MIL-M-28787/312(SH)
AMENDMENT 2
24 August 1990
SUPERSEDING
AMENDMENT 1
11 April 1983

MODULES, STANDARD ELECTRONIC

DRIVER, TRANSLATOR, DIGITAL, KEY CODE DLB

FIGURE 10. Static output voltage (high-level and low-level) test circuit for tables VIII and IX.

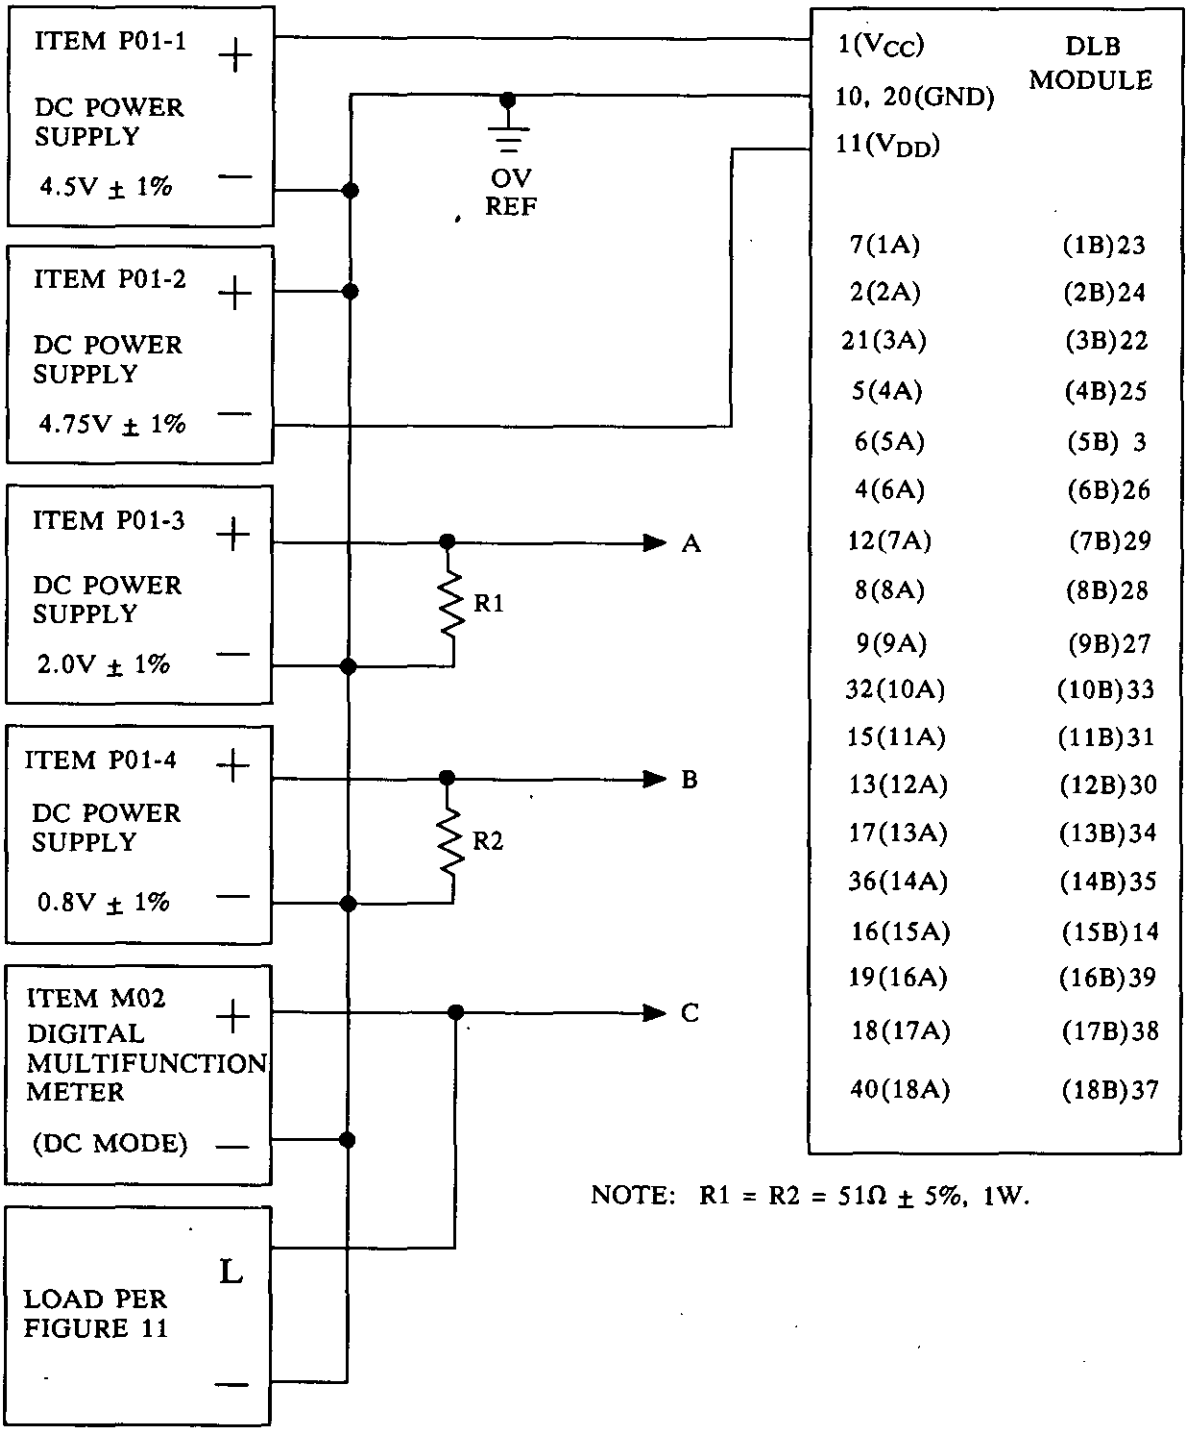
FIGURE 10: Delete and substitute new figure 10 as printed on page 3 of this amendment.

NOTE: R1 = R2 = 51Ω ± 5%, 1W.
